P 516935
A Repair

**ON-SITE SEWAGE DISPOSAL SYSTEM
HOWARD COUNTY HEALTH DEPARTMENT
BUREAU OF ENVIRONMENTAL HEALTH**

ADDRESS: 1290 Driver Road PROPERTY OWNER: Robert Norton

4516935

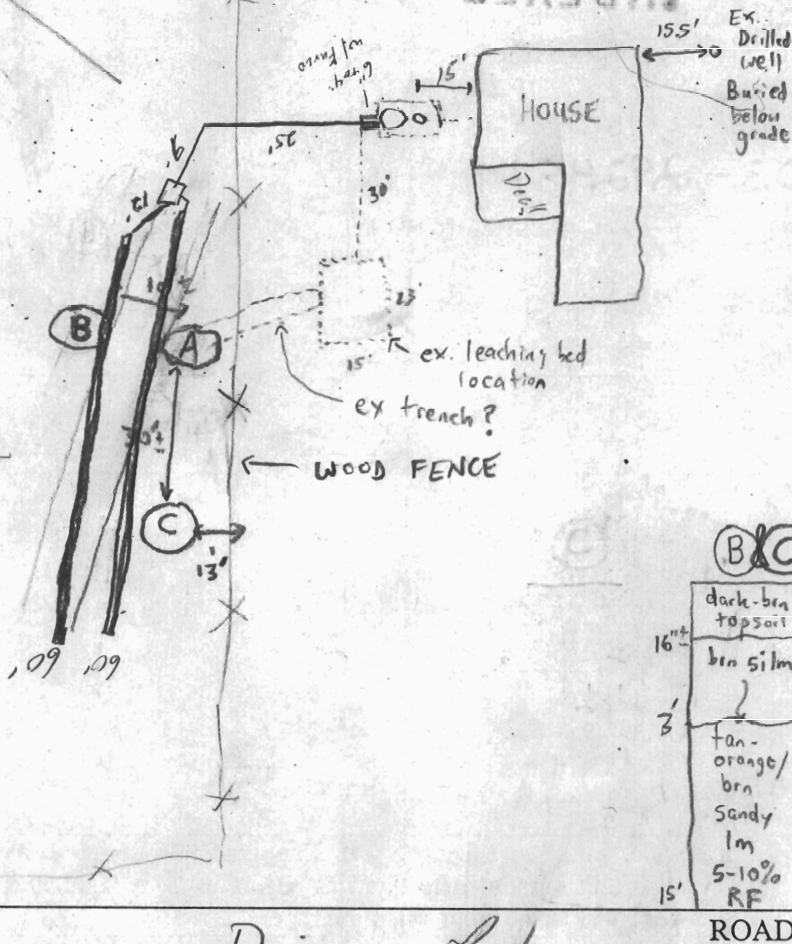
AREA OF BLEED OUT "PONDED SEWAGE"

PRE-CONSTRUCTION 4/17/02 - MET INSTALLER & HOMEOWNER, EXCAVATED EX. SYSTEM (TANK & UNPERMITTED TRENCH OFF OF EX. LEACHING BED (HOLE A), EXCAVATED HOLES (B) & (C) OK (SEE SOIL PROFILE) RUN 2-60' TRENCHES ON CONTOUR (8' ETE - 10' CTC) - (SO/SRK) 4/18/02. Soils look good in trenches, OK to cover all work (SO)

PERMIT CARD

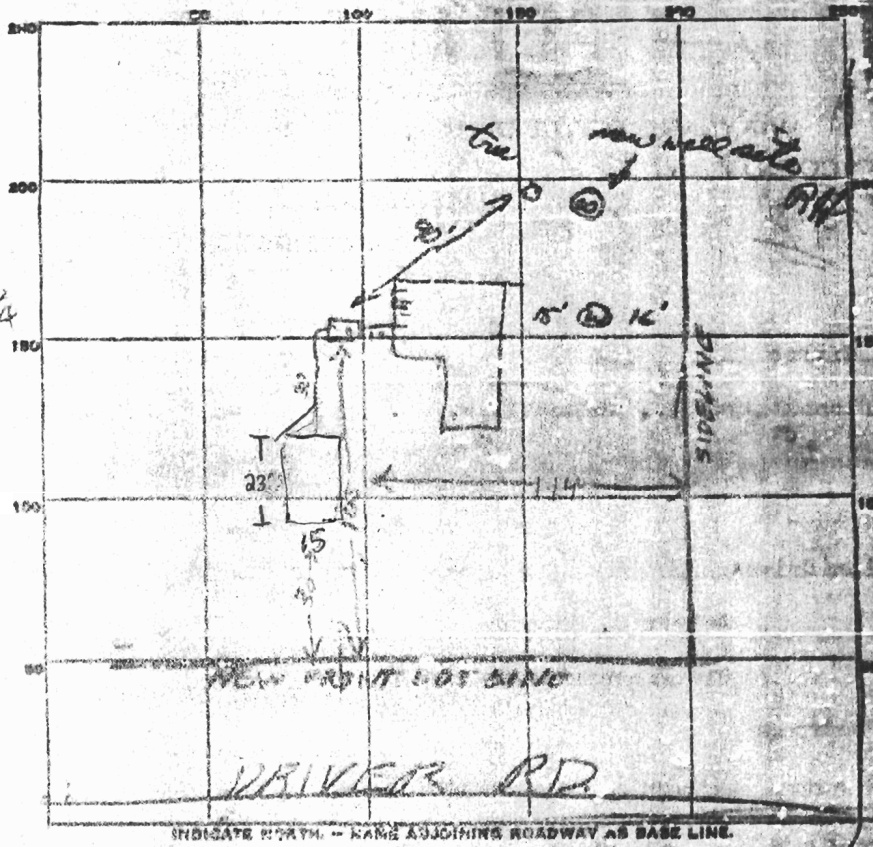
REMARKS 25 JAN 65 - I do not think it will be possible to put bed at depth 10 to 30 ft from the front lot line here when the tank is 140-150 from the front lot line on this lot. Recommend Retest.

27 JAN 65 - General checked this again. There was a new front lot line & tank is much closer to holes. We checked fall from septic tank to Leaching bed & it seemed OK.

29 JAN 65 - OK Hold in bed depth & retest
DATE SYSTEM APPROVED 29 Jan 65 INSPECTOR Layman Hodge
